# Final Environmental Impact Report for City of Santa Barbara's and Ionics, Incorporated's Temporary Emergency Desalination Project

SB-106-90

State Clearinghouse No. 9010859

March 1991

Figure 2-3

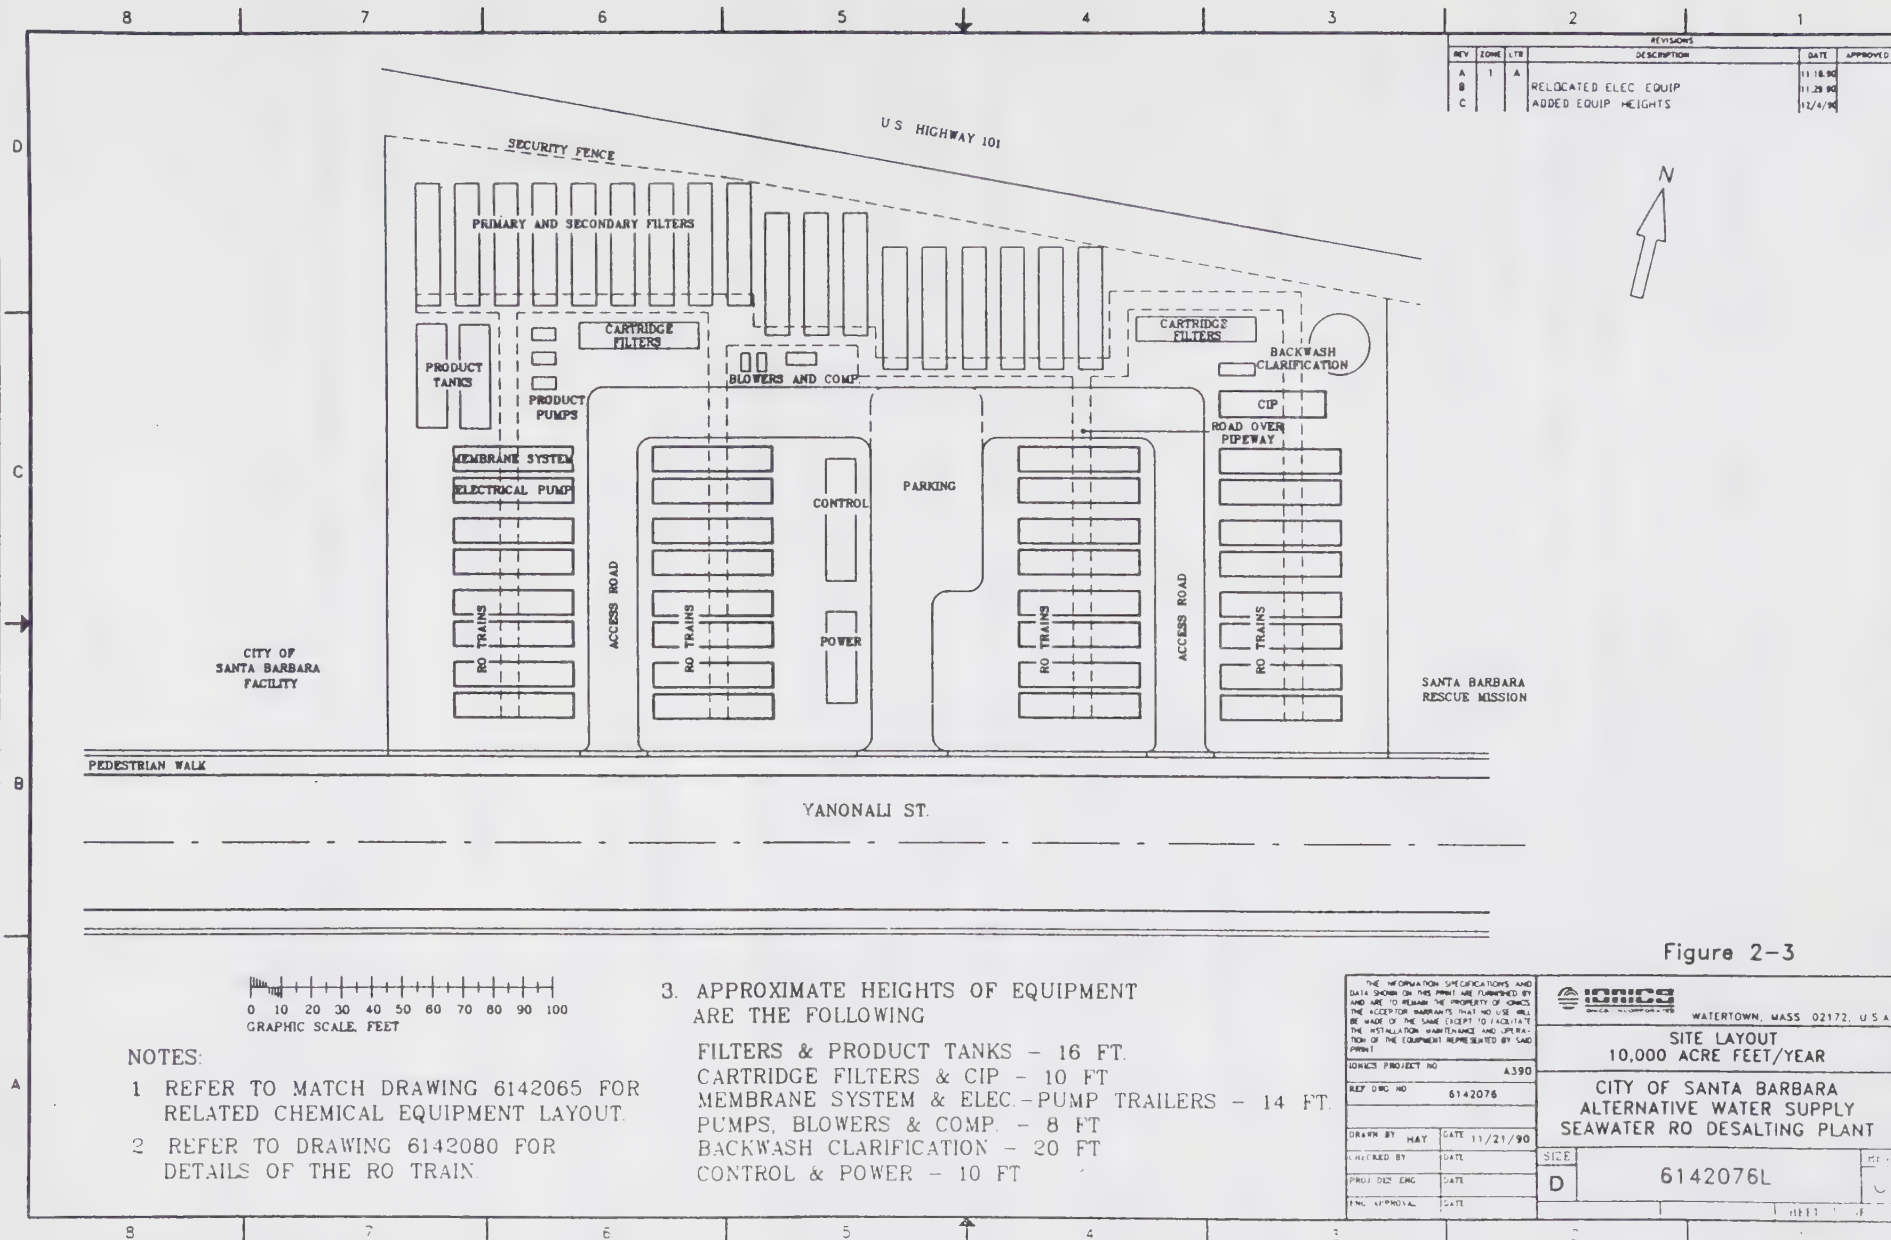
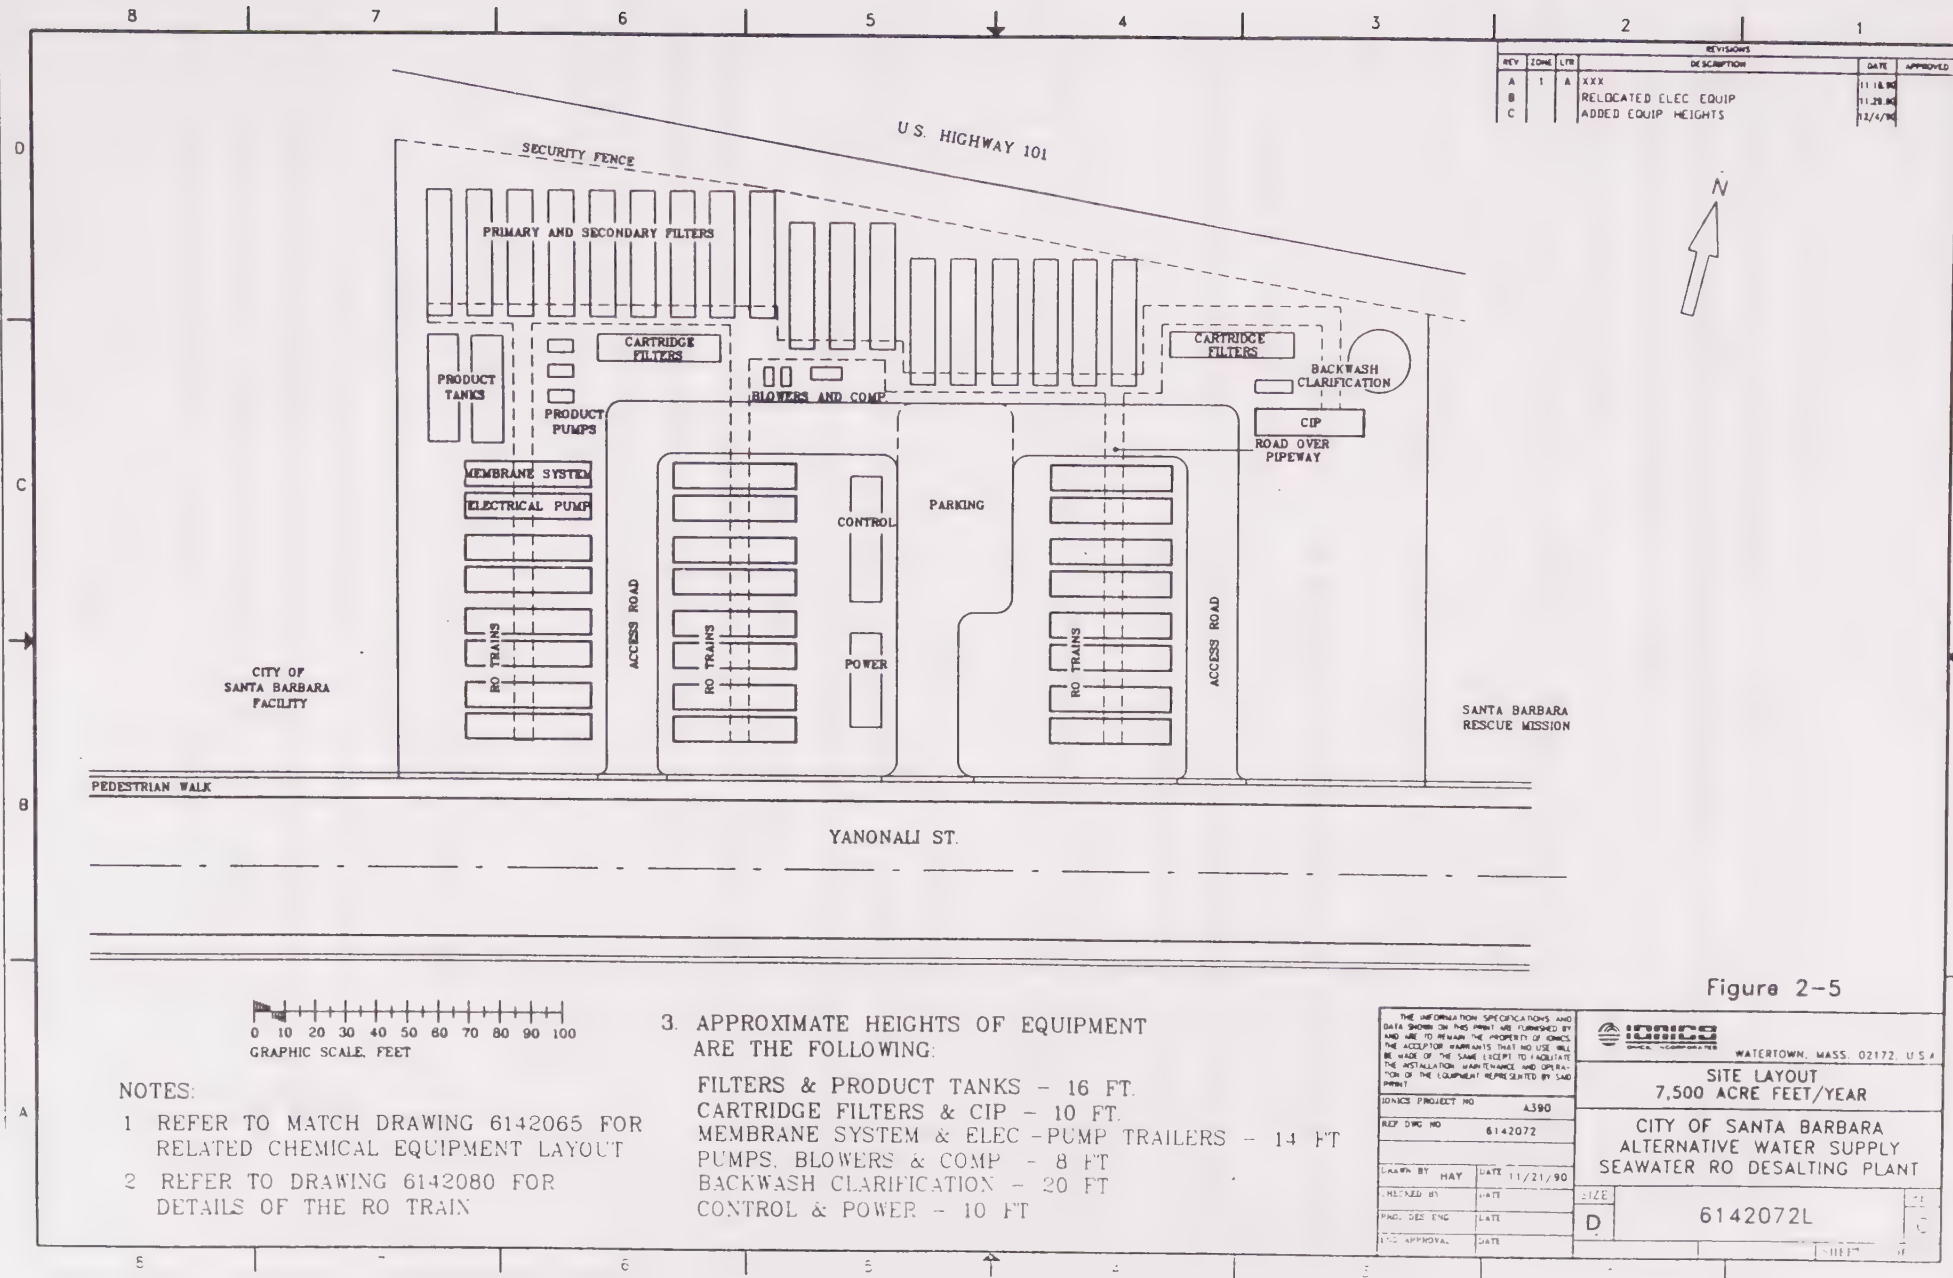
Response 9-22: The commentor incorrectly claims that there has not been data provided regarding the clarifier or dewatering filter press in the EIR, and that there is probably not enough room at the site for these facilities without reducing the capacity of the desalination facility. In actuality, both of these facilities are addressed in the EIR. The clarifier is shown on the artist's rendering in the lower left hand corner (tank structure), and on Figures 2-3 and 2-5 on the northeast corner of the site. As listed on the figures, the backwash clarifier is 20 feet tall (i.e., tallest structure at site). The dewatering filter press is also shown on Figures 2-3 and 2-5 to the west of the backwash clarifier; due to space limitations on the

figures, the press was not labeled. Labels for the dewatering filter press have been added to Figures 2-3 and 2-5 in the Final EIR.

Figure 2-7. PROPOSED INTAKE LINER  
INSTALLATION TECHNIQUE FROM WEIR BOX  
ON BEACH

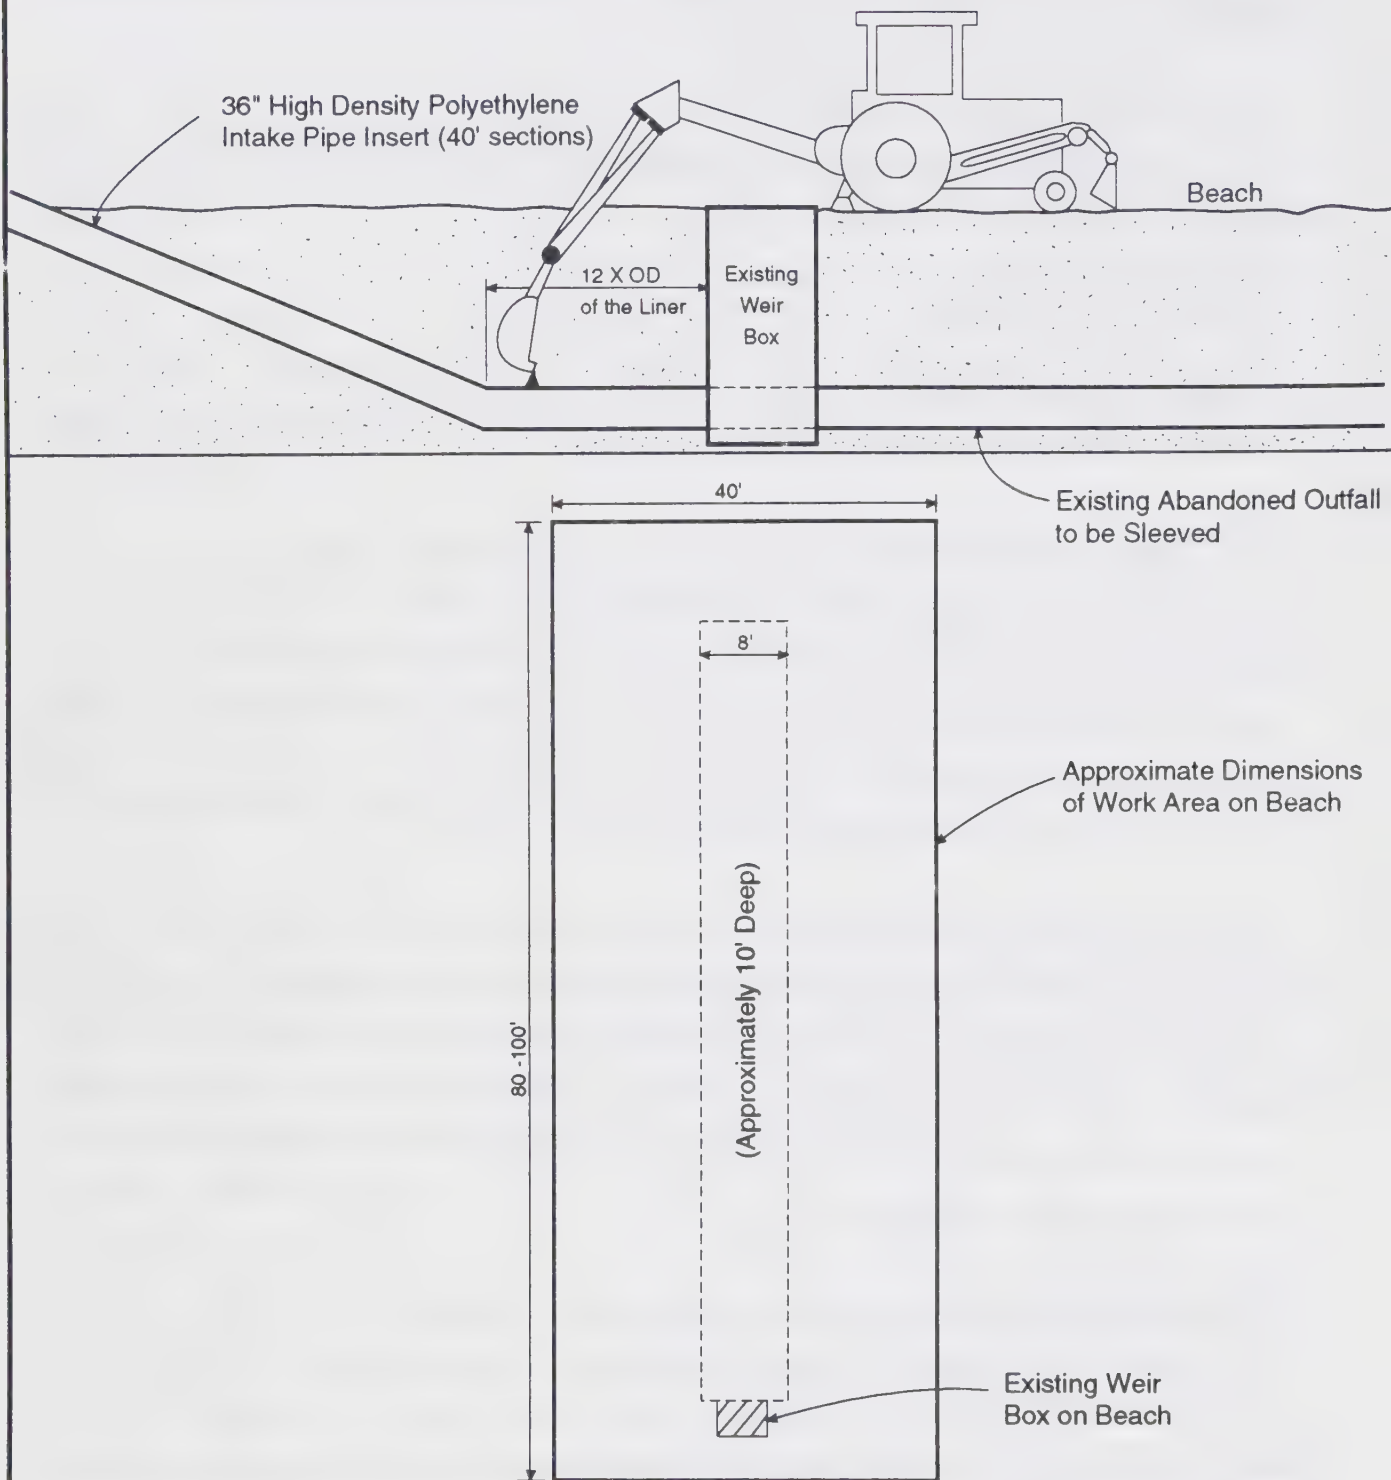
Response 17-38: The "size of the beach area which will be fenced off during excavation activities" for safety purposes is shown on Figure 2-7 in the EIR and is approximately 40 feet by 100 feet maximum.
